December 5, 2017

Re: Comments on Draft Total Maximum Daily Load (TMDL) analysis for three reaches of Queen Creek located near Superior, AZ

Permitted Cu Discharges by RCM Into Queen Creek at Outfall 002

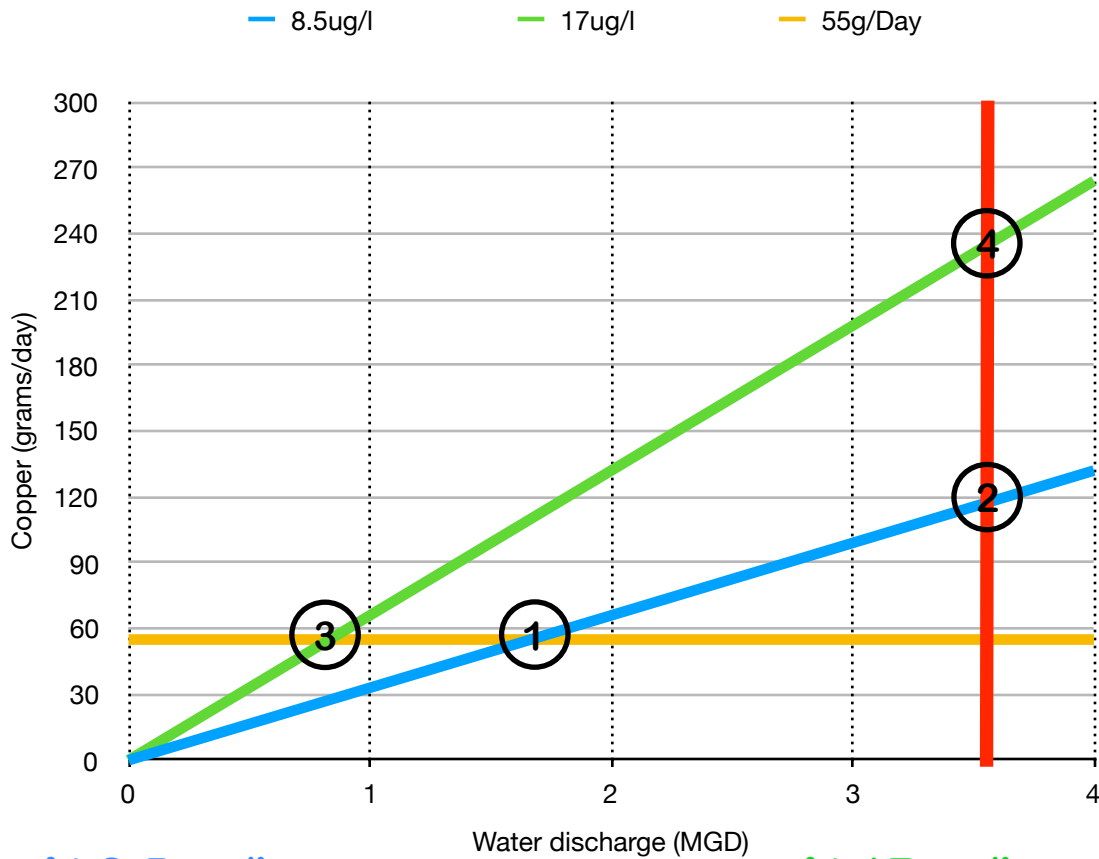
As shown in Table 1.b., above, taken from the AZPDES Draft Permit, Resolution Copper’s AZPDES permit provides for an average monthly discharge limit of 8.5 µg/L and a daily maximum limit of 17 µg/L, with a 1x/month monitoring frequency.⁷ However with no mass limit calculated in the TMDL (regardless of continuous or non-continuous discharging status), **it is almost certain that Resolution Copper’s daily discharges will exceed daily TMDL load limits for copper at water volumes far below what Resolution Copper has estimated it will discharge under its AZPDES permit to Outfall 002.**⁸ This is likely to result in daily violations, even at relatively low discharge volumes. *See Attachment A.*

Under Resolution Copper’s own estimated maximum daily discharge of 3.6 MGD to Outfall 002 (or 13,627,482.42 Liters), the 55 grams/day TMDL limit would be exceeded by a factor of two. **In other words, the daily load of copper into Queen Creek would be 115.8 grams – more than twice the TMDL daily load impairment level of 55 grams per day.** If Resolution should discharge at the higher daily maximum concentration limit of 17µg/L, the daily discharge would then be some 420% of the TMDL impairment limit.

① TMDL daily mass limit (55 grams of Cu per day) is exceeded when 1,708,235 gallons are discharged

③ TMDL daily mass limit (55 grams of Cu per day) is exceeded when 854,118 gallons are discharged

② Total Cu discharged at RCM's 3,600,000 MGD estimated daily discharge volume?

④ Total Cu discharged at RCM's 3,600,000 MGD estimated daily discharge volume?
